McKinleyville Community Services District McCluski Tank Replacement Design Project Request for Qualifications Bid Addendum #1

This Addendum addresses the following items and questions:

JOB NO.
70-40A
SHEET
39

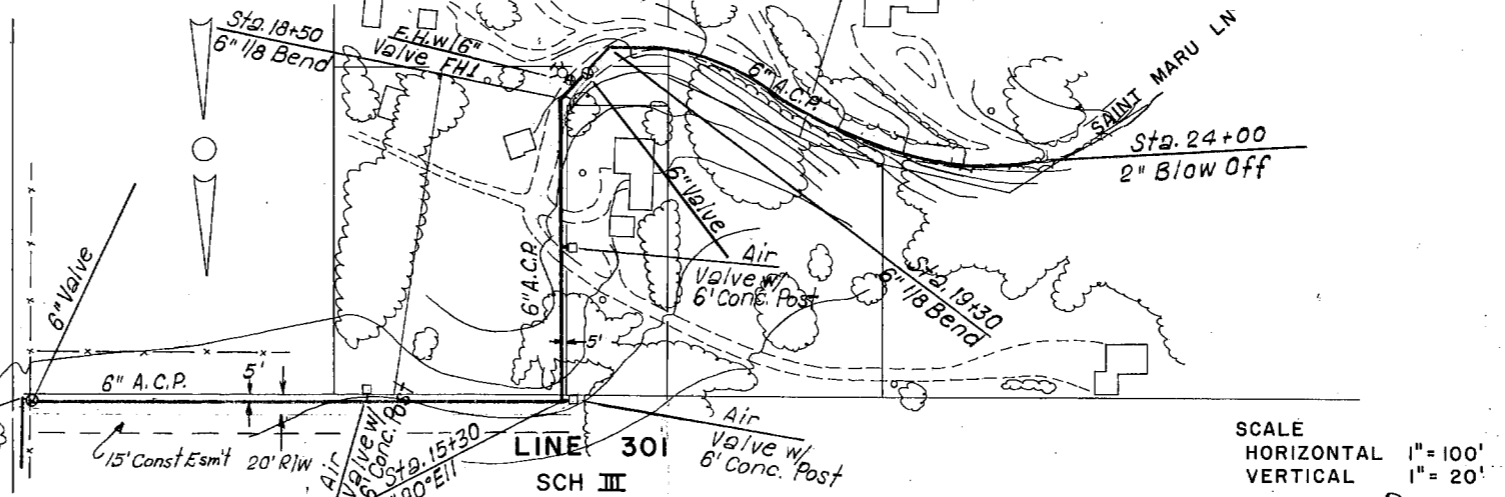
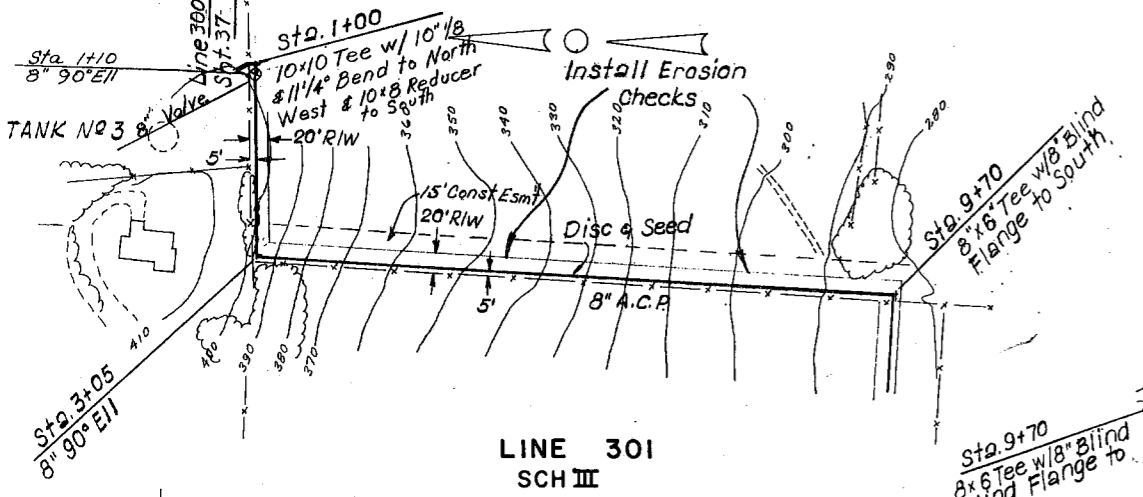
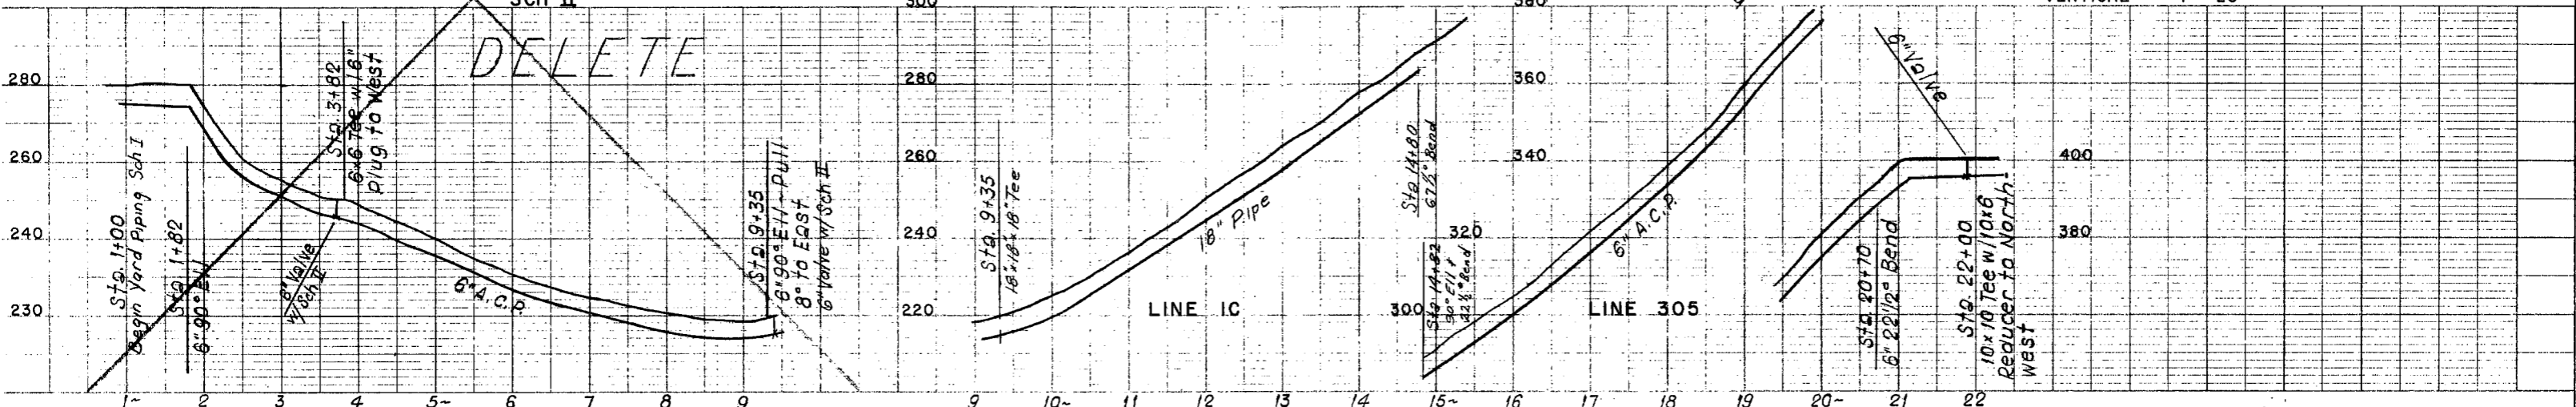
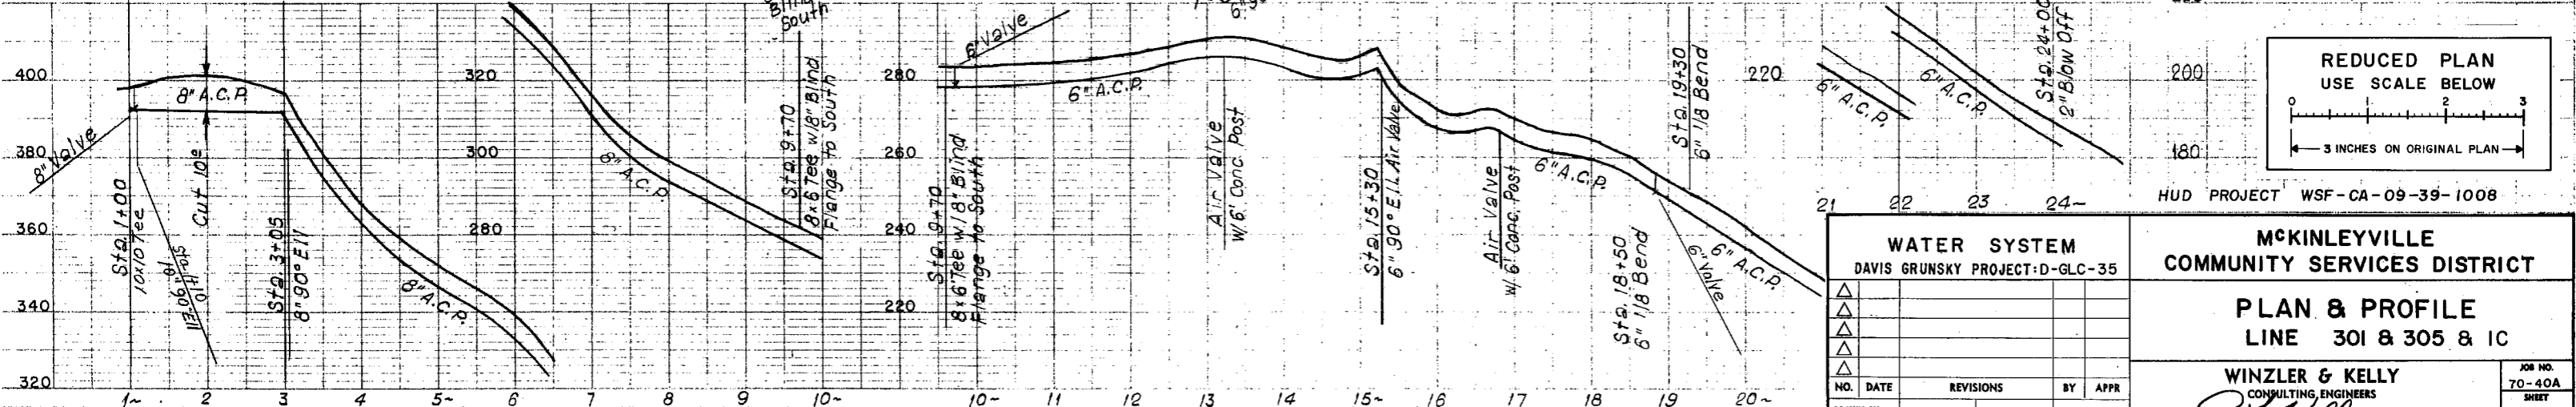
4. Record drawings:
 - Would it be possible to get copies of the record drawings for the 150,000-gal tank (including yard piping drawing)?
 - Can we get a copy of drawing number 39 from the 100,000-gal tank record drawings?

See attached drawings:

- Sheet 39
- Photos for the Site Plan and details for the 150,000-gallon tank. Unfortunately, the District does not have electronic versions of these drawings.
